IEEE802.3dj Modal ERL Proposal

Addressing d2.3 comments 40, 41, 42

Richard Mellitz, Samtec

March 2026, Vancouver, BC, Canada IEEE P802.3dj Plenary

Modal Pulse Time-Domain Reflections

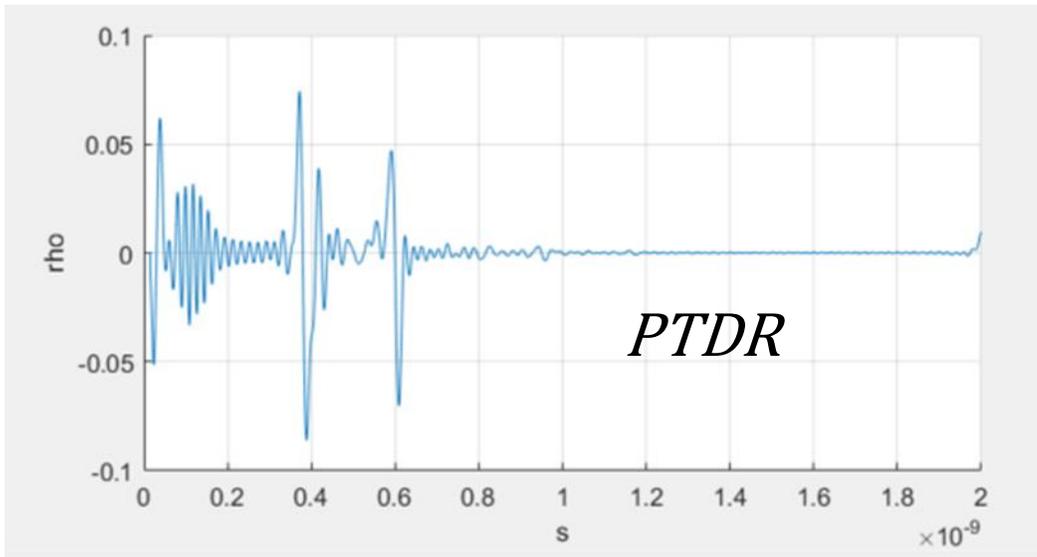
- ❑ Using the filtered return loss functions compute modal *PDTR* using ERL *PTDR* as the basis
- ❑ Reference modal S-parameter naming as defined in 178A.1.2

The filtered modal return losses functions $H_{ccii}(f)$, $H_{cdii}(f)$, and $H_{dcii}(f)$ are defined by Equations (178A–61)

The modal pulse TDR signals $PTDR_{cc}(t)$, $PTDR_{cd}(t)$, and $PTDR_{dc}(t)$ are defined by Equation (178A–62).

$$PTDR_{cc}(t) = \int_{-\infty}^{\infty} X(f) H_{ccii}(f) \exp(j2\pi ft) df \quad (178A-62a)$$

$$PTDR_{cd}(t) = \int_{-\infty}^{\infty} X(f) H_{cdii}(f) \exp(j2\pi ft) df \quad (178A-62b)$$

$$PTDR_{dc}(t) = \int_{-\infty}^{\infty} X(f) H_{dcii}(f) \exp(j2\pi ft) df \quad (178A-62c)$$

Effective modal reflection waveforms

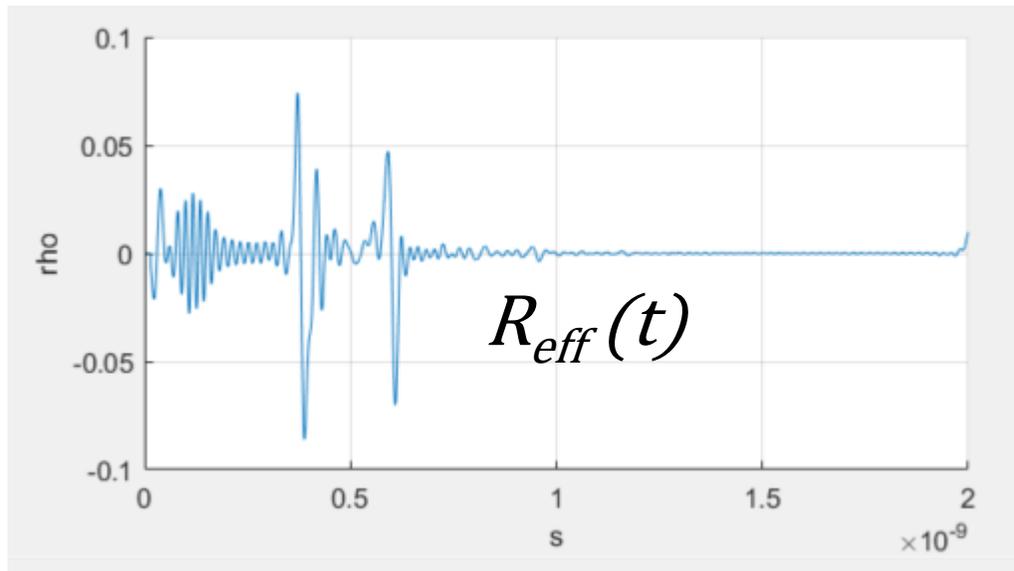
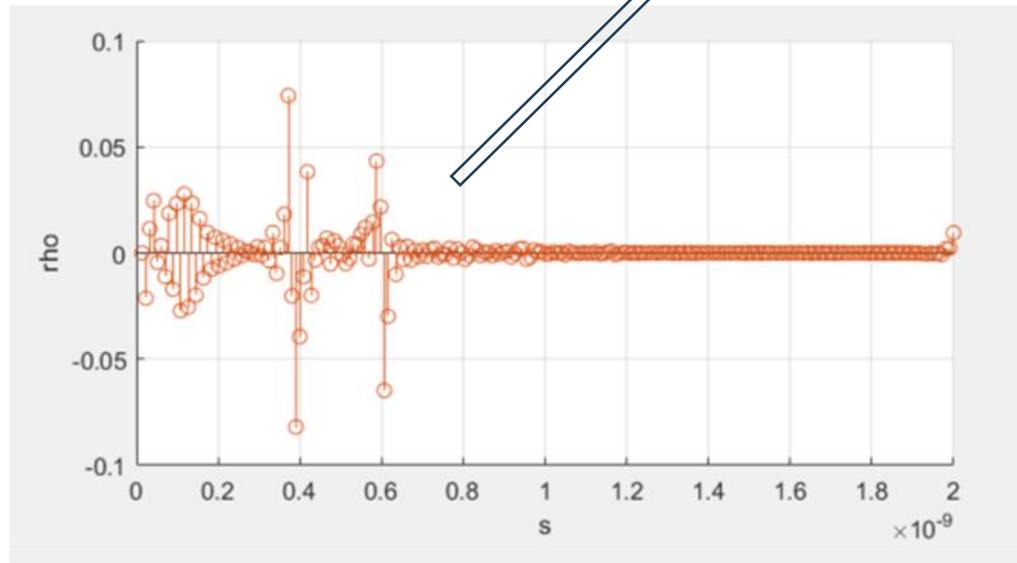
- Compute effective modal reflection waveforms, $R_{eff}(t)$, from modal $PTDR$ using 93A gating functions (G_{rr} and G_{loss})

The effective modal reflection waveforms $R_{cceff}(t)$, $R_{cdeff}(t)$, and $R_{dceff}(t)$ are computed by time gating and weighting the PTDR waveforms $PTDR_{cc}(t)$, $PTDR_{cd}(t)$, and $PTDR_{dc}(t)$ per Equation (178A-63). $R_{cceff}(t)$, $R_{cdeff}(t)$, and $R_{dceff}(t)$ are pure numbers.

$$R_{cceff}(t) = PTDR_{cc}(t) \times G_{rr}(t) \times G_{loss}(t) \quad (178A-63a)$$

$$R_{cdeff}(t) = PTDR_{cd}(t) \times G_{rr}(t) \times G_{loss}(t) \quad (178A-63b)$$

$$R_{dceff}(t) = PTDR_{dc}(t) \times G_{rr}(t) \times G_{loss}(t) \quad (178A-63c)$$

Sample Variances

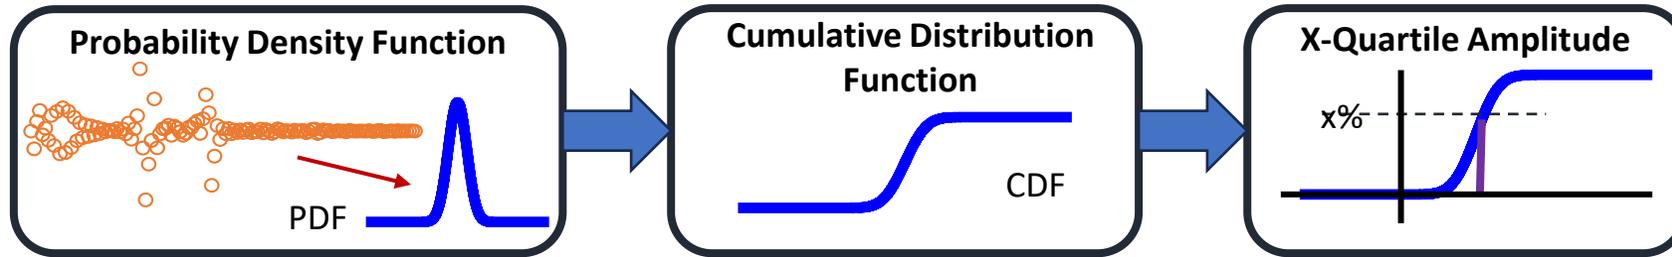
- ❑ Compute reflection variance for each reflection sample offset

The standard deviation of the distributions of the modal reflection signals for each phase m for s is defined by Equation (178A-65).

$$\sigma_{cch}^{(m)} = \sqrt{\sum_{n=1}^N \left(h_{cc}^{(m)}(n) \right)^2} \quad (178A-65a)$$

$$\sigma_{cdh}^{(m)} = \sqrt{\sum_{n=1}^N \left(h_{cd}^{(m)}(n) \right)^2} \quad (178A-65b)$$

$$\sigma_{dch}^{(m)} = \sqrt{\sum_{n=1}^N \left(h_{dc}^{(m)}(n) \right)^2} \quad (178A-65c)$$
